RE: ADDITIONAL INFORMATION REQUESTED FOR THE MOORE RANCH IN
SITU URANIUM RECOVERY PROJECT LICENSE APPLICATION (TAC
JU011), SAFETY EVALUATION REPORT OPEN ISSUES.

Hydrology Open Issue No. 17
Restoration of groundwater to the standards in 10 CFR part 40, Appendix A,
criterion 5B is not proposed
May 11 2009 Teleconference

Radiological Open Issue No. 6a
Quantity of radioactive material released to unrestricted areas
July 27 2009 Teleconference

Question 4.4.2.3.2 Wellfield Spills

Figure 1. The Location of Air Monitoring Stations for the Moore Ranch Site.

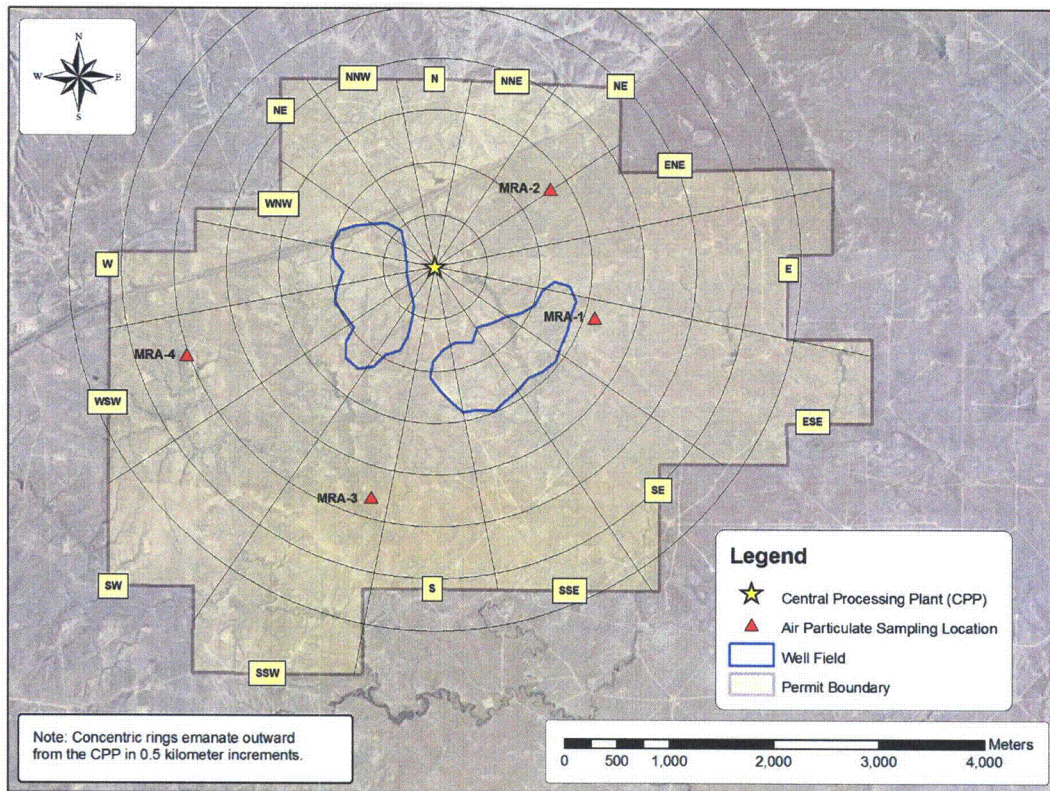
The applicant shows the air particulate and radon sampling locations in Figure 5.7-2, however, the applicant does not identify these air particulate and radon sampling locations by sector or distance. The applicant has not provided sufficient information demonstrating that the three site boundary air particulate and radon sampling stations have been placed in locations and sectors that have the highest predicted concentrations of airborne particulate that is consistent with Regulatory Guide 4.14. The staff notes that the location of the air particulate and radon sampling locations may have an impact on the proposed soil sampling locations.

Figure 1 below shows the air monitoring locations, the sector with respect to the central processing plant, and the distance from the central processing plant. The predominant wind direction as discussed in Section 2.5.2.4 of the Technical Report is from the southwest to west sectors and is from these sectors 40% of the time.

MRA-1 is approximately 1.5 kilometers from the central processing plant in the east-southeast sector. This location is well positioned to monitoring potential airborne emissions from the site carried by winds from the west.

MRA-2 is approximately 1.3 kilometers from the central processing plant bordering the northeast and east-northeast sector. This location is well positioned to monitor potential airborne emissions from the site carried by winds from the southwest.

MRA-3 is approximately 2.4 kilometers from the central processing plant in the south-southwest sector. This location is well positioned to monitoring potential airborne emissions from the site carried by winds from the north and north-northeast sectors.

MRA-4 is approximately 2.5 kilometers from the central processing plant in the west-southwest sector. This location is well positioned to monitor background conditions since the predominant winds are from the southwest to west sectors.
